ALERT SERVICE BULLETIN

Exchange of turbocharger/exhaust clamps on ROTAX® Engine Type 915 i (Series) and 916 i (Series)

ATA System: 78-10-00 Exhaust system

MANDATORY

Fig. 1

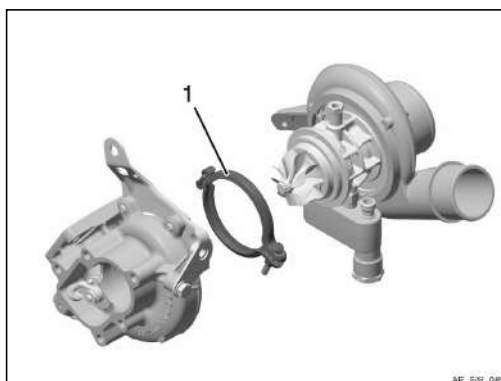
Part no.	Qty/ engine	Description	Application
651873	1	clamp assy. 83 mm	Turbocharger hot section
651873	1	clamp assy. 83 mm	Exhaust elbow (916 i Series only)

Fig. 3

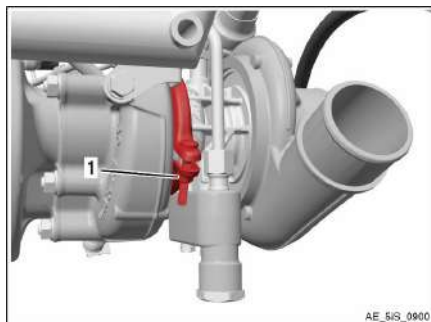
Step	Procedure
1	Loosen Hex. nut M8 (1) from turbocharger clamp. NOTE: Support the turbocharger center housing and cold section.
2	Remove the clamp.

Fig. 4
Turbocharger clamp assy.

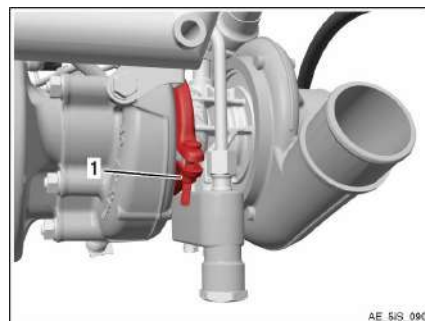
Step	Procedure
1	Hold the turbocharger center housing and cold section in position on the hot section.
2	Place clamp into position between center housing and hot section, in the orientation depicted.
3	Hand tighten the clamp Hex. nut M8 (1). Check the alignment of center housing and hot section. Tighten clamp Hex. nut M8. Tightening torque 8 Nm (70 in. lb).

Fig. 5
Exhaust elbow

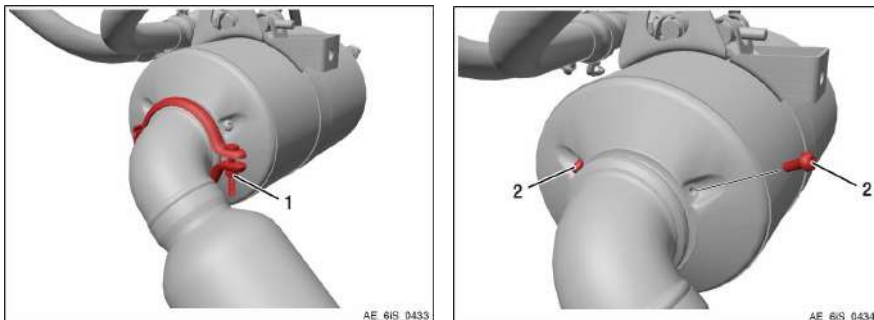
916 i (Series) engines use the same clamp assy. part no. 651873 for the attachment of exhaust elbow.

Step	Procedure
1	Loosen M8 Hex. nut (1) from exhaust elbow clamp. NOTE: The exhaust elbow is held in position by 3 screw M5x12 (2). See current Maintenance Manual Heavy (MMH) for the respective engine type, Chapters 78-00-00, 78-10-00 and Chapter 78-20-00.
2	Remove the clamp.

Fig. 6
Exhaust elbow clamp assy.

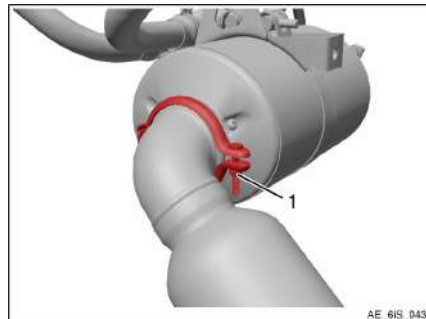
Step	Procedure
1	Place clamp into position between the exhaust muffler and exhaust elbow, in the orientation depicted.
2	Tighten clamp Hex. nut M8. Tightening torque 8 Nm (70 in. lb).
